**AGENDA**  
**HAILEY PLANNING & ZONING COMMISSION**  
**Monday, August 22, 2016**  
**Meeting to convene at 609 and 611 South Main Street at 5:30pm**  
**Meeting to reconvene at Hailey City Hall at approximately 5:45pm**

[NB 1](#) Continuation of the Design Review Application by D.L. Evans Bank, represented by Tom Lennon and Andy Erstad of Erstad Architects, for a new 4,595 square foot bank branch to be located at 609 South Main Street (Lots 1-8, Block 5 Hailey Townsite) and 611 South Main Street in the Business (B) and Townsite Overlay (TO) Zoning Districts.

**TO:** Hailey Planning and Zoning Commission

**site plan**

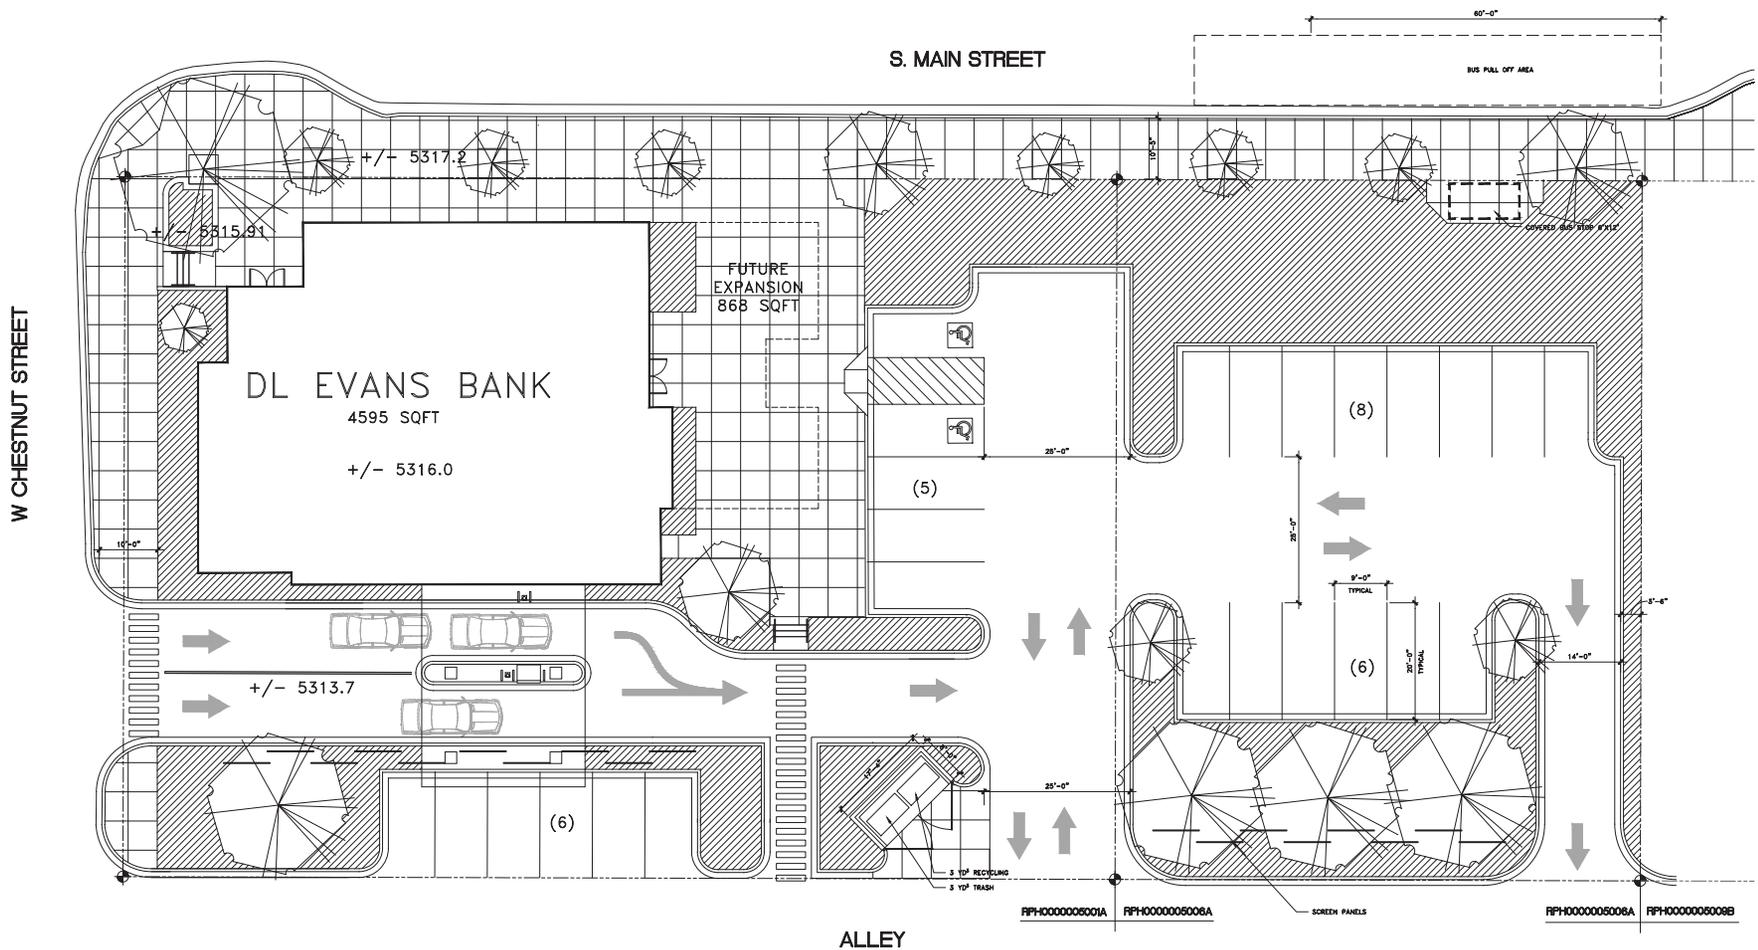
<p><i>incorporated into the conditions of approval. The site plan shows the specimen oak on the northeast corner as being retained. However, the undisturbed area under the tree needs to be increase to a minimum of ½ to 2/3 of the tree canopy.</i></p> <p><i>Regarding the interior trees, further site evaluation with Tree Committee members has suggested that the mature maple in the vicinity of the southern parking lot is a valuable mature specimen tree. This tree could provide nice shade for the excess parking area. It appears as if this tree can be retained. Additionally staff recommends the addition of two crabapple or similar species in the 30' wide plating strip separating the most southerly parking lot from the public street.</i></p>
<input checked="" type="checkbox"/>	<input type="checkbox"/>	<input type="checkbox"/>	<p><b>17.06.080(A)1c</b></p> <p><b>c. Site circulation shall be designed so pedestrians have safe access to and through the site and to building.</b></p> <p><i>Staff Comments</i></p> <p><i>Pedestrians access the building from the front sidewalk or the back parking area in a safe manner. The revised site plan meets the Mobility standards for a 10' sidewalk on Main Street. A striped walkway crosses the drive-through zone leading in to the perennial bed area.</i></p> <p><i>The applicant is proposing to remove the residential curb cut on to Main Street, which would become a commercial grade curb cut. Commercial curb cuts on Main Street are undesirable, and staff supports the elimination of this curb cut.</i></p> <p><i>Staff recommends an additional pedestrian access from the southerly parking lot to the bus shelter.</i></p>

- k) The curb cut on Main Street shall be eliminated.
- l) The 19 stall parking lot on Main Street is in excess of City regulations, but has been found to meet the standards herein, so long as this parking area is permitted to be used by transit riders, and for events at Werthheimer Park. The parking stall shall be modified as follows: 1) A pedestrian path shall be provided connection this parking area to the Main Street sidewalk/bus shelter area. 2) One of the two handicap stall shown in the portion of the parking lot closest to the building shall be relocated into the southern portion of the lot. 3) A trash receptacle shall be added in the vicinity of the bus shelter.

- m) The bus shelter as shown on the revised drawings is a requirement of the site plan, with the following modifications: 1) adequate lighting shall be shown (it is unclear from the current plans how it will be lit); 2) The bus pull-out area needs to have a no-parking, red curb zone of at least 80' along the Main St curb face, at the bus shelter location; and 3) the current roof design may cause snow to slide off onto waiting passengers: the pitch of the roof shall be modified and approved by staff.

- n) A letter from Clearcreek Disposal shall be provided stating that the location and design is adequate for dumpster pickup.
- o) The pad-mounted transformer shall be shown on the site plan.

elevations  
 a3.11

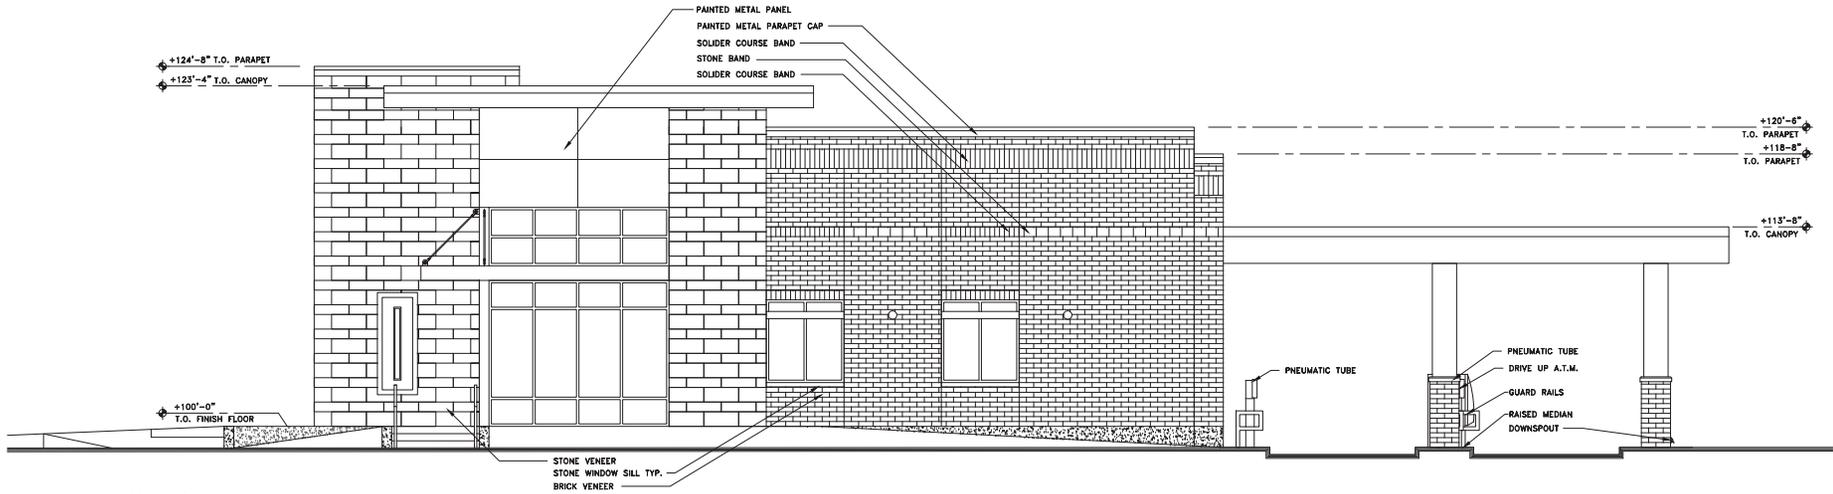
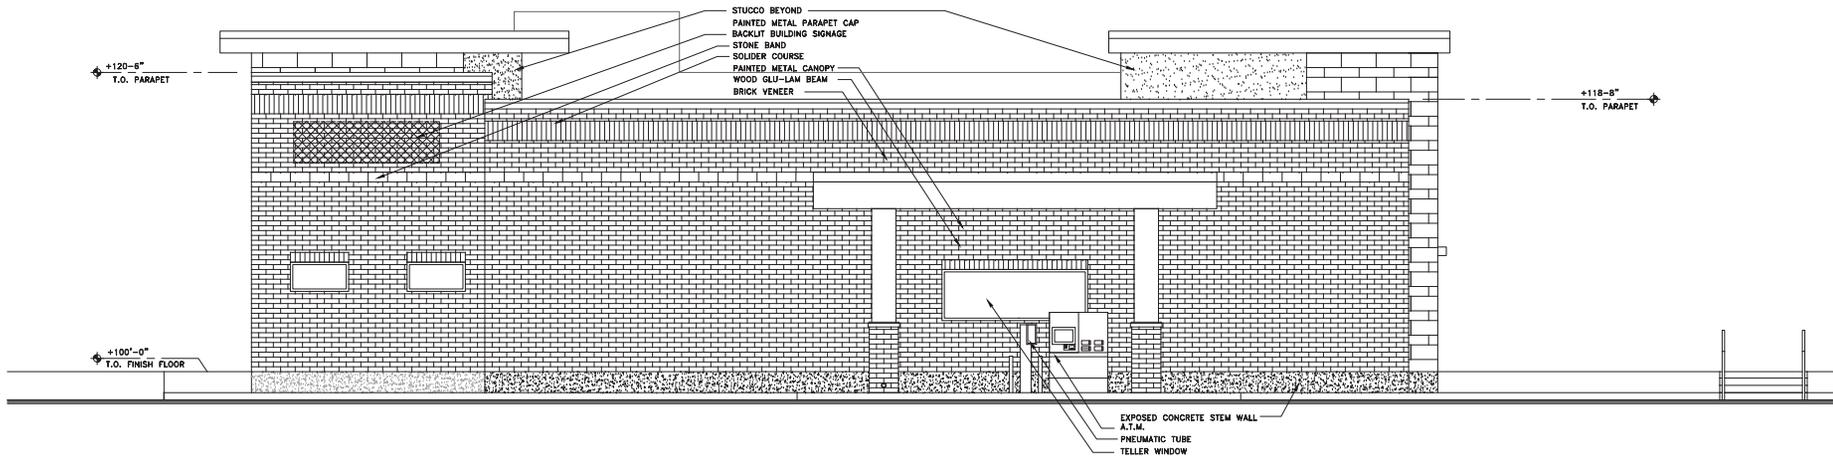
<i>Staff Comments</i>	<i>The main entry / front façade faces Main Street and has multiple windows sheltered by a canopy and columns which breaks up the larger roof form above.</i>
<input type="checkbox"/>	<input type="checkbox"/>	<input checked="" type="checkbox"/>	17.06.080(A)2e	<b>e. Any addition onto or renovation of an existing building shall be designed to create a cohesive whole.</b>
			<i>Staff Comments</i>	<i>No plans for future expansion have been shown at this time.</i>
<input checked="" type="checkbox"/>	<input type="checkbox"/>	<input type="checkbox"/>	17.06.080(A)2f	<b>f. All exterior walls of a building shall incorporate the use of varying materials, textures and colors.</b>
			<i>Staff Comments</i>	<i>A variety of materials will be used on the exterior: stucco, brick veneer, soldier course, exposed metal columns.</i>
<input checked="" type="checkbox"/>	<input type="checkbox"/>	<input type="checkbox"/>	17.06.080(A)2g	<b>g. Exterior buildings colors and materials shall be integrated appropriately into the architecture of the building and be harmonious within the project and with surrounding buildings.</b>

**SITE PLAN**  
**EXISTING TREES**

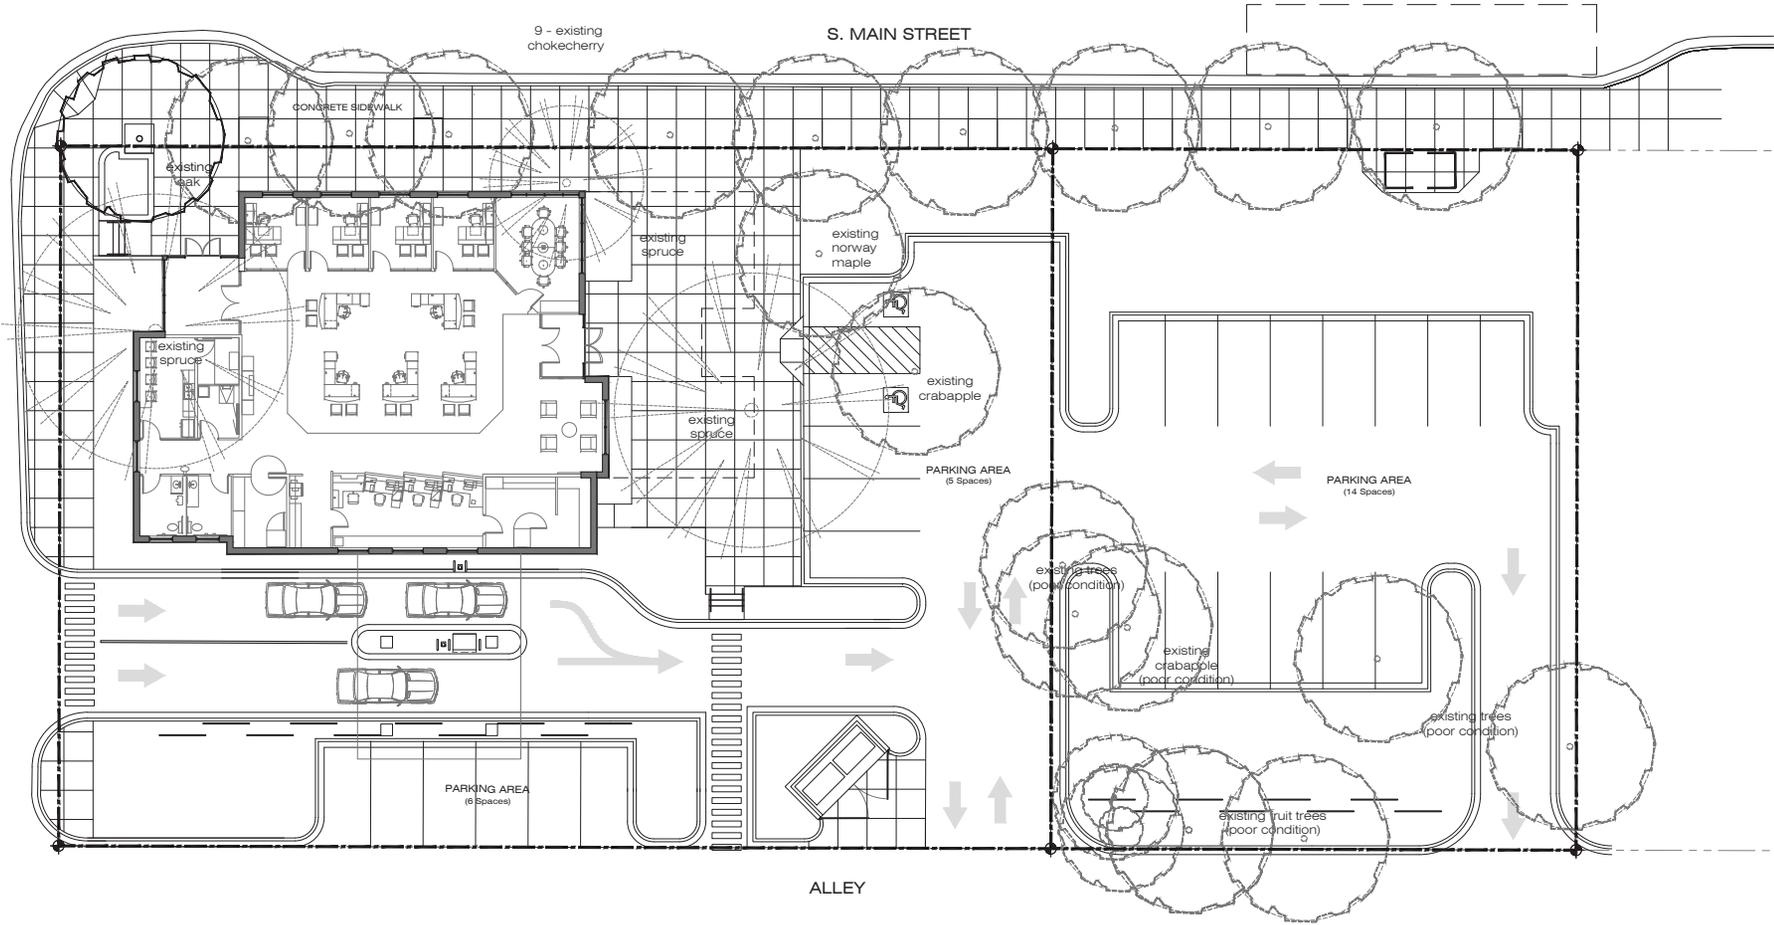
Shubert Chokecherry Street Trees: The primary issues are a 18"-2' grade change for the chokecherry street trees at the back of curb, and how well these particular trees may perform over time. They are below the grade of the new building, and they will end up in a narrow tree well wedged between a foundation and the existing sidewalk. Carl and I felt that since the property is now almost the whole block (DL Evans has brought in the residential lot all the way south to the Hitch rack, so they are redeveloping almost the whole block) that it may be an opportunity to replace these chokecherries with a different species, with a proper soil base, and to have them all at grade. We discussed a crimson maple or similar so that the new street trees would

Private Trees: We also felt that the applicant should save 1 or 2 of the deciduous trees in the interior of the lot. In particular the Maple interior is in good shape, and will provide excellent shade for the parking lot. Your group had also mentioned a crab in this area. We could see which one works best with the parking layout.

The cherry trees are in fair health but a short lived species. They need good drainage. I agree they won't adapt well to the plan and should be replaced. I also strongly agree that the oak should be saved. I like the idea of keeping the maple in the interior instead of the crabapple. It has a much better shape and habit for a parking lot tree.
